Midway City Council  
20 September 2022  
Regular Meeting

Resolution 2022-34 /  
Watts Remund Farms  
Master Plan Agreement  
Third Amendment

**CITY COUNCIL MEETING STAFF REPORT**

**NAME OF PROJECT:** Watts Remund Farms Planned Unit Development Phase 5

WATTS ENTERPRISES  
 REMUND FARMS  
 MASTER PLAN  
 AMENDMENT 2021

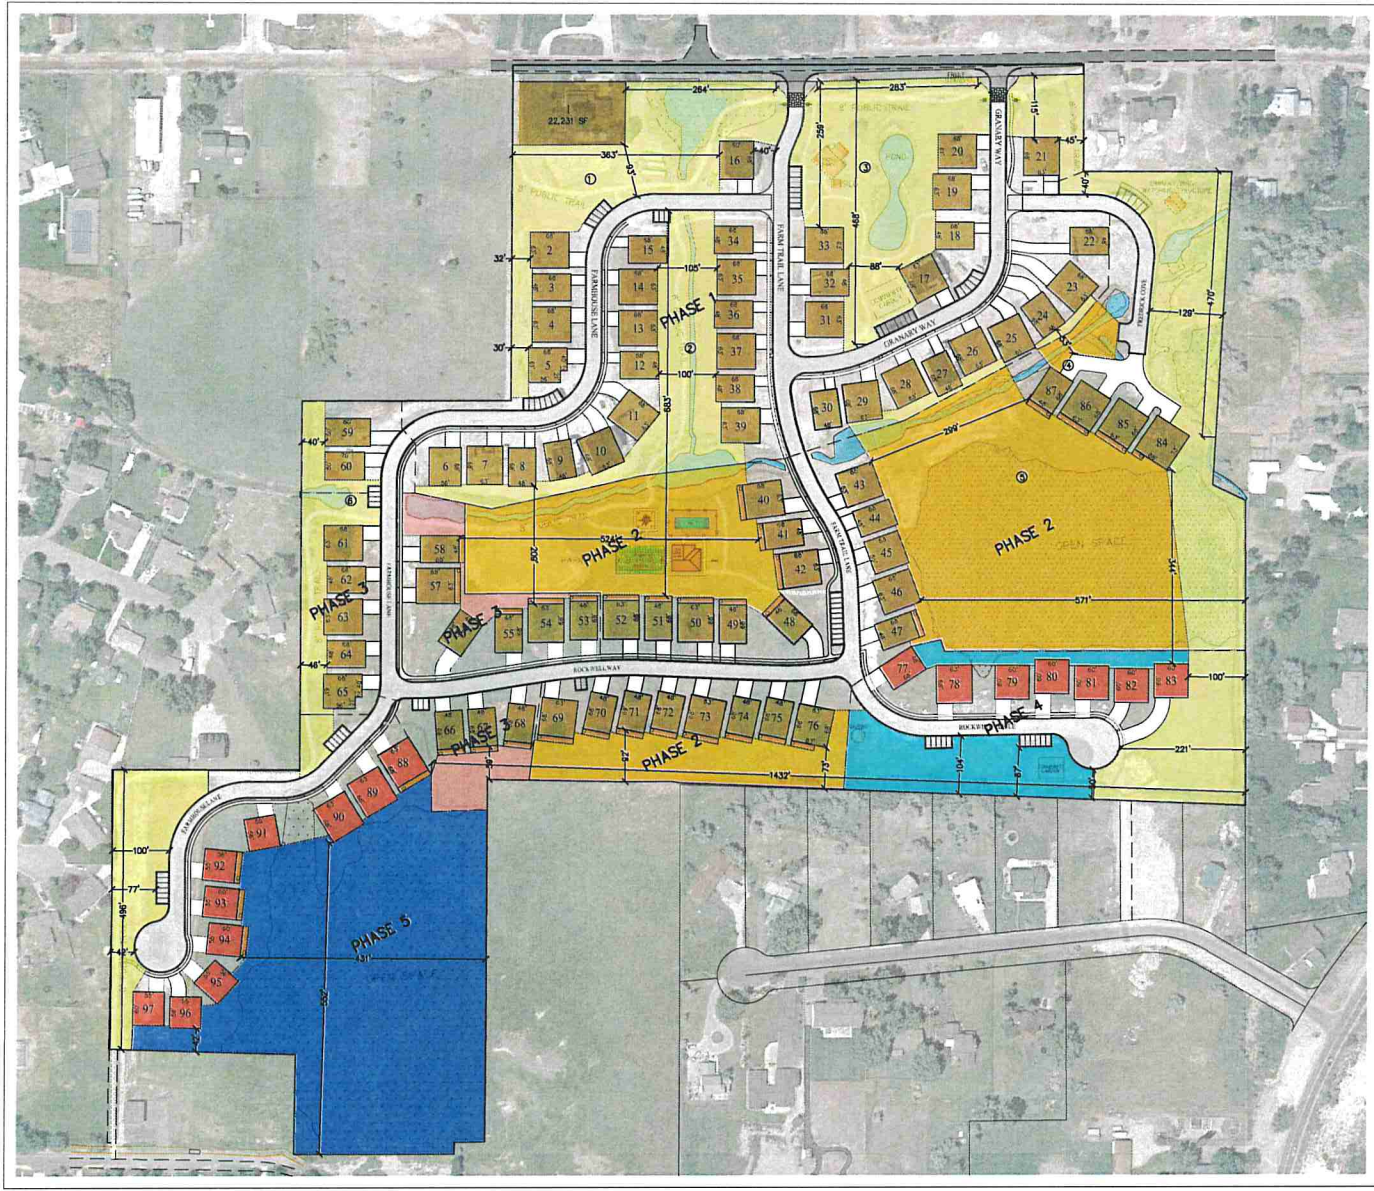
*Setbacks to neighboring properties* – The proposed adjustments to the building pads create an overall enlargement of the pads, resulting in some cases in reduced setbacks from the units to the neighboring properties. The current land use code for PUDs requires building setbacks from the peripheral boundary to be a minimum of 60’. This project is vested under a previous code requirement that allowed for a 30’ building setback from the peripheral boundary. In phase 5, it appears as though a few of the setbacks from the units to the neighboring properties to the east and south have decreased. The setback to the east decreased from 431’ to 412’. The setback to the south will not change and will remain at 42’.

**REVISIONS NOTE: - 9-13-2021**  
 UNITS 91-97 HAVE BEEN ADJUSTED TO ADDRESS CITY COUNCIL COMMENTS FROM 9-7-2021 TO PROVIDE A 42" SETBACK FOR THE PHILPOT PROPERTY.

Horrocks Engineers  
Remund Farms Subdivision  
Groundwater Elevation Differential  
July 20, 2018 to July 15, 2022

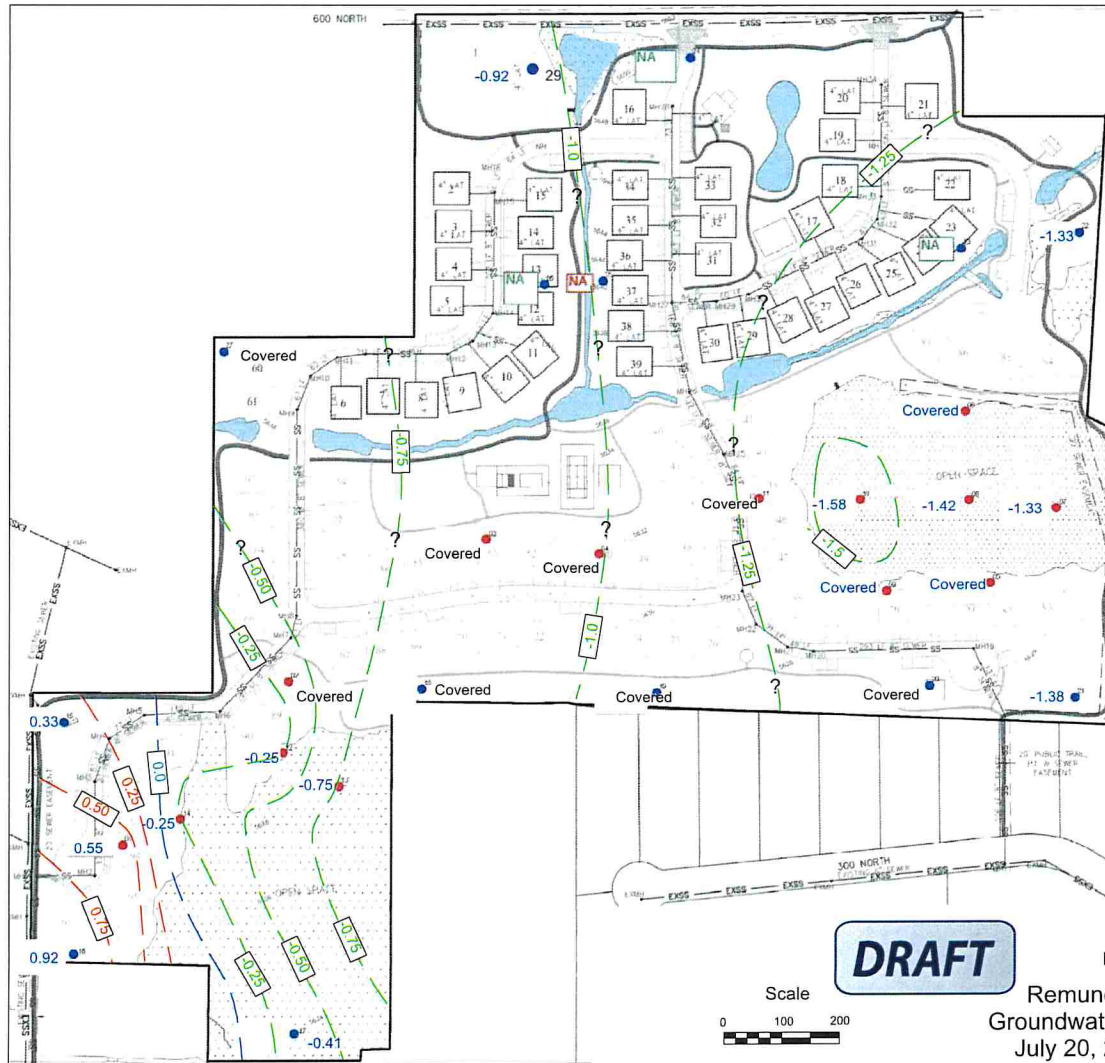
To address the issue, a plan was devised to monitor the water table in the development and the surrounding area, and the City hired the well-respected water firm of Loughlin Water Associates to monitor the results. Per plan, the developer installed, at least, 25 piezometers (22 on-site and three off-site, located on the southside of 250 North). They also installed an equalization perforated pipe on Cathy Philpot's property located north of 250 North to drain the extra water in the area that was suspected to be caused from the installation of the infrastructure in the development. Since the installation of the equalization perforated drainpipe, the water table has stabilized to levels similar to preconstruction levels (see attached documents titled "Remund Farms Subdivision Groundwater Elevation Differential). Staff does have some concerns about the limited length of time that monitoring has occurred and the fact that Midway is in the middle of a 20+ year drought but the data does look promising, and neighbors have not voiced any concerns in recent months.
